CHOLLA POWER PLANT Fly Ash Dam, Bottom Ash Dam, Sedimentation Pond, and Bottom Ash Monofill

Annual CCR Impoundment and Landfill Inspection Report

2018

20181022 – IMG_0290

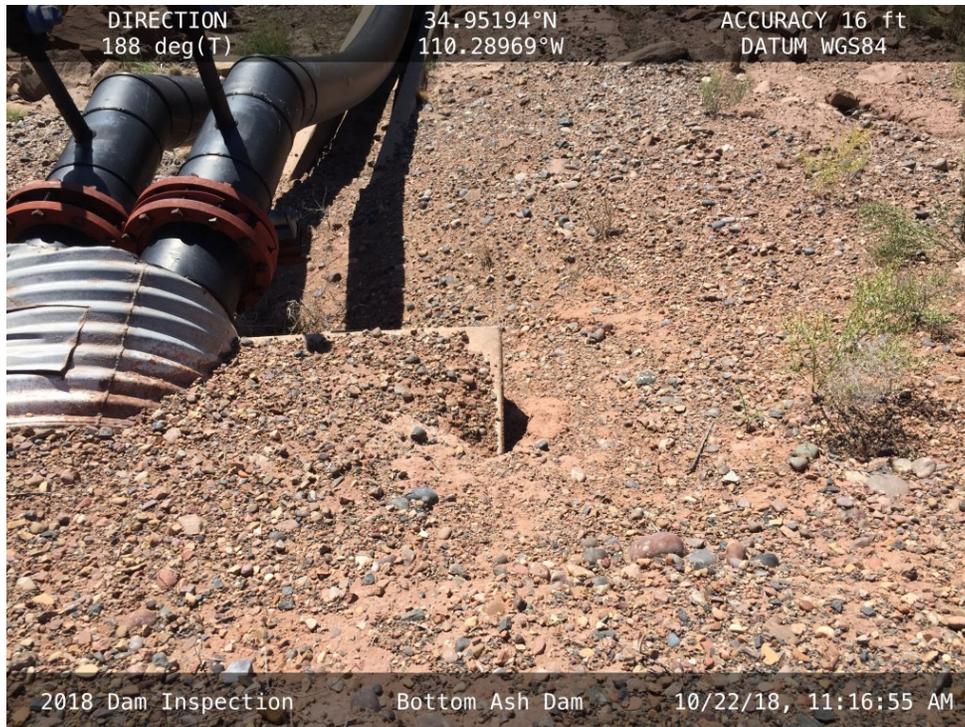
- ii. Shallow erosion rills were observed in isolated locations along the South Embankment crest (Photos IMG_0280 and IMG_0283). These areas should be monitored and repaired if they are observed to exceed a depth of 1 foot.

Shallow erosion on the upstream slope and crest near the western siphon line.

20181022 – IMG_0296

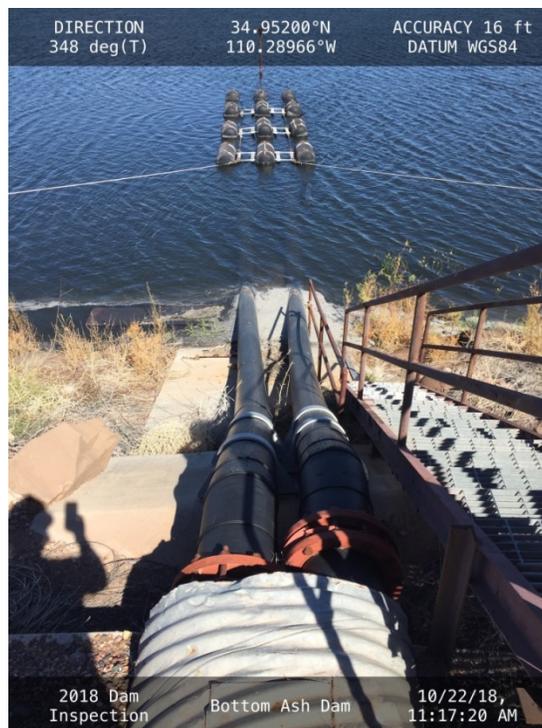
- iii. Minor erosion, soil wasting, and erosion gullies were observed:
 - a. Minor erosion was observed on the downstream slope around the concrete encasement for the central siphon lines (Photo IMG_0296).

Minor erosion around the concrete encasement for the central siphon lines, facing downstream.
